| Title - Sujet Replacement Salt Shed | |
| Solicitation No. - N° de l'invitation EZ899-150376/C | Amendment No. - N° modif. 001 |

Please find following Addendum No. 1.

ESK-1

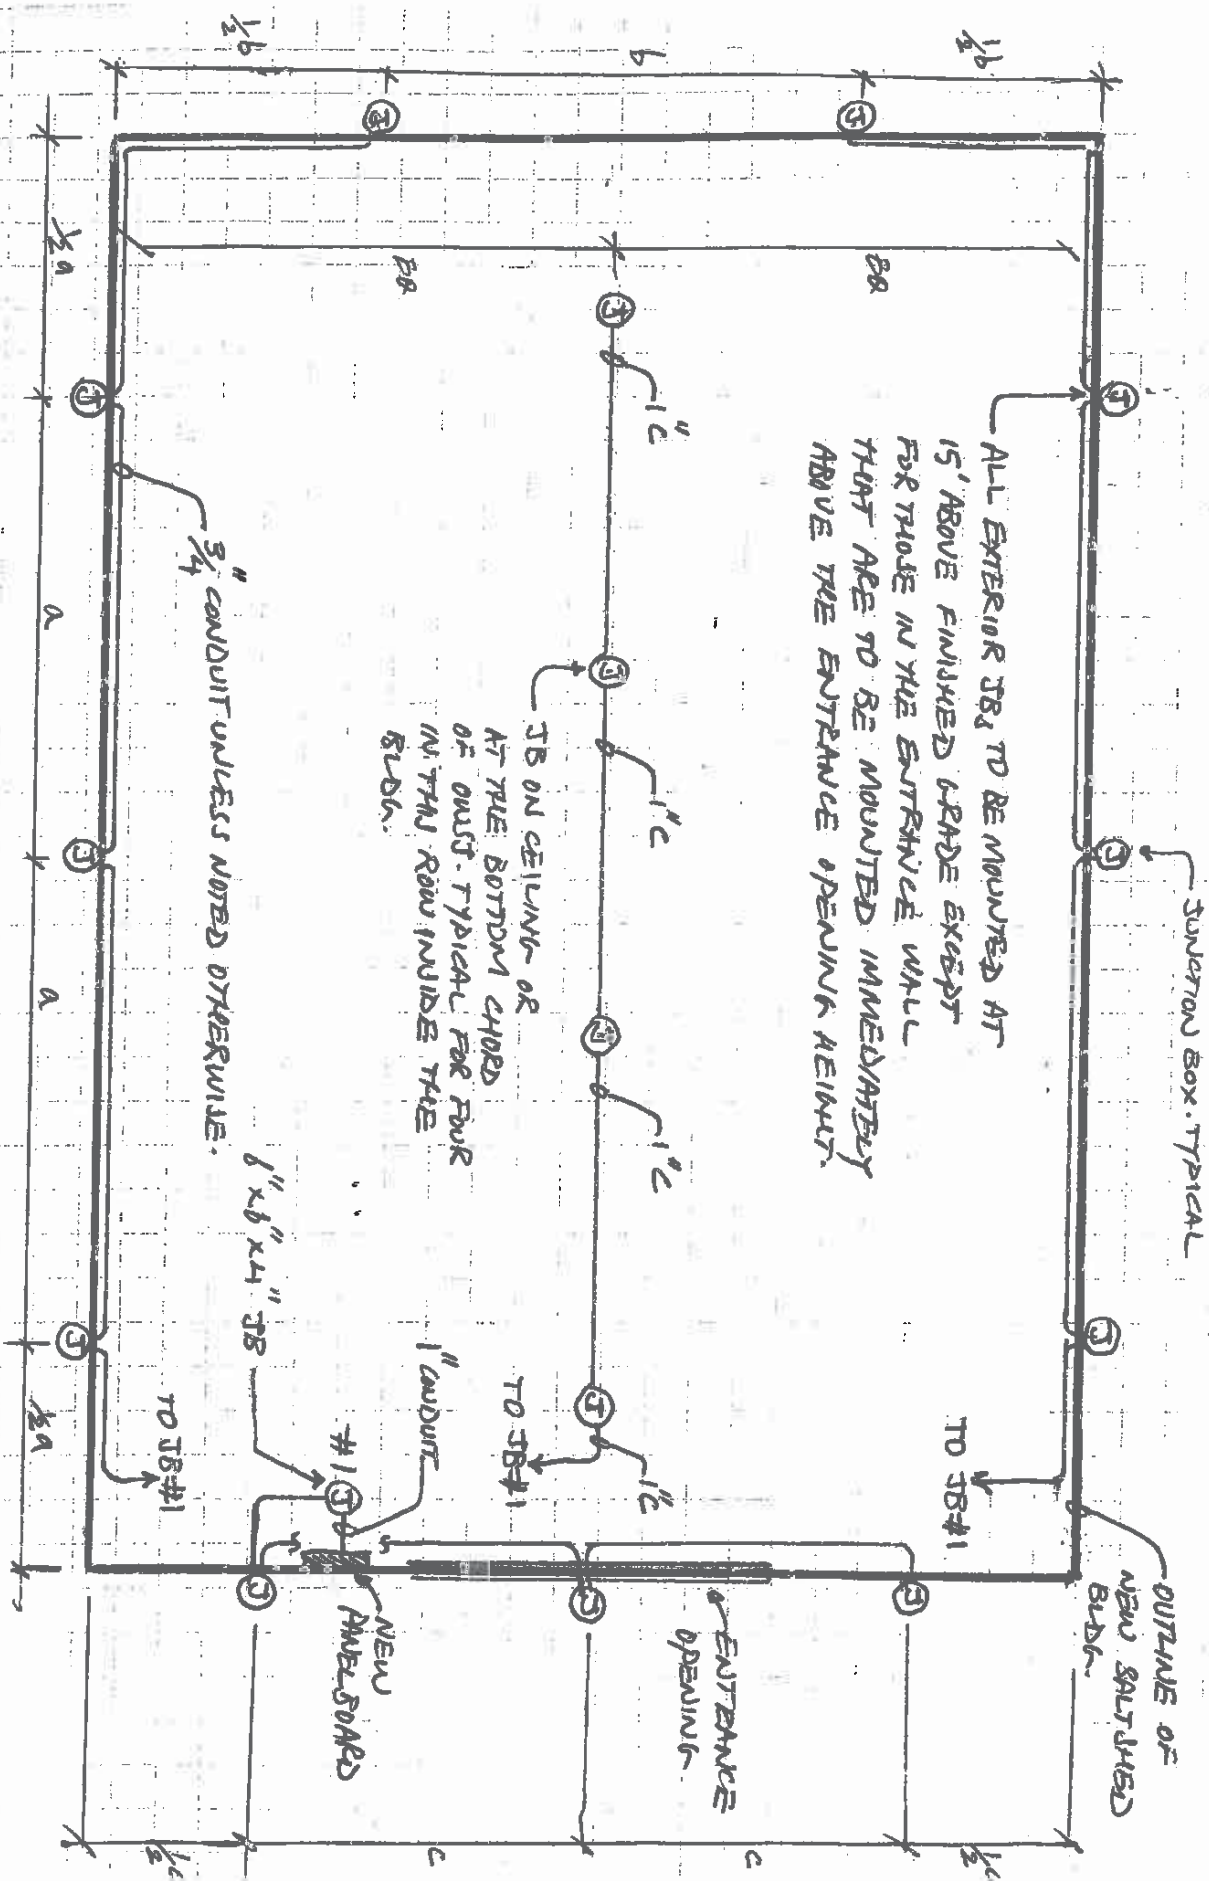
- (1) **Replace** ESK-1 with the sketch included in this addendum.

- (1) **Replace:** Entire clause with the following:
 - “1. Provide provisions – conduit and junction boxes only – for future interior and exterior lighting installation. Refer to ESK-1 for details.
 2. Install pull string in all conduit runs.
 3. Installation of all conduit and junction boxes, in both interior and exterior of the building, shall be in accordance with clause 1.8 – Wiring Methods.
 4. Provide cover plate for all junction boxes suitable for the installation.”
